# Product Information Notice

**Models:** Greenstar Combi 151p (7738100611)

**Subject:** Incorrect Hydraulic Connection Plate

Figure 1

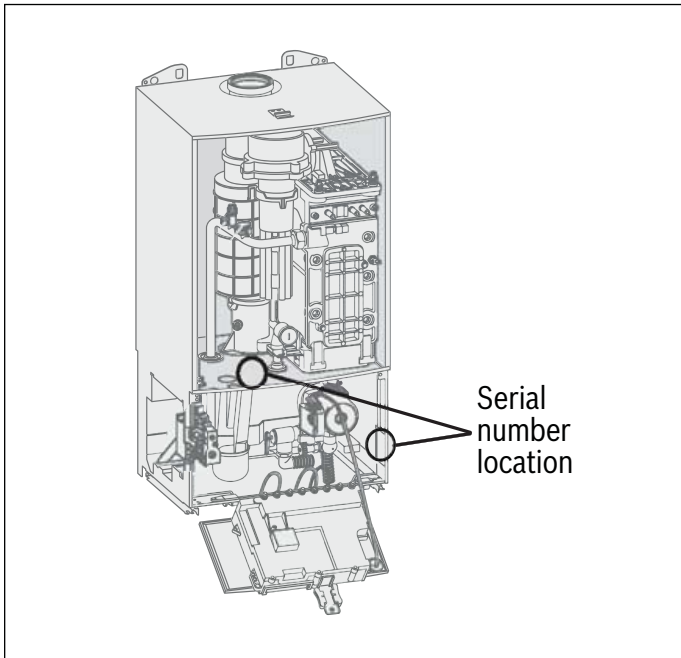
The boiler serial number is located on top of the packaging box or on the inside of the boiler (see fig1.)

Figure 3 Correct hydraulic connection plate dimensions

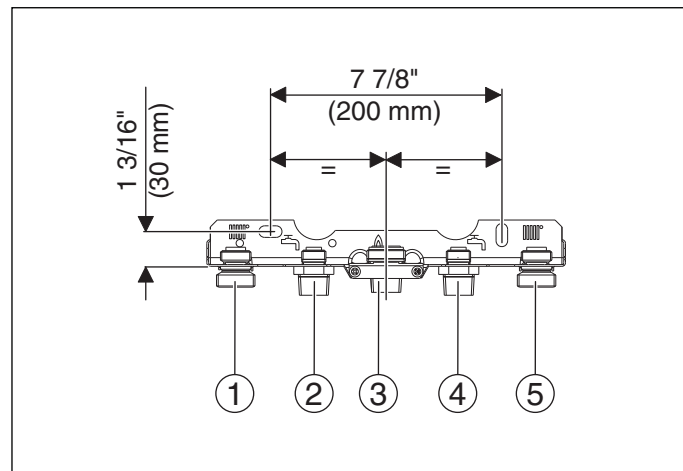
A limited amount of Greenstar Combi 151p boilers were packaged with a hydraulic connection plate (p/n: 87186616160) containing incorrect connection fittings. These connections are not NPT and will not properly connect to the boiler (see fig2.)

- [1] Heating supply, R 1" NPT
- [2] DHW, R 3/4" NPT
- [3] Gas, R 3/4" NPT
- [4] Cold water, R 3/4" NPT
- [5] Heating return, R 1" NPT
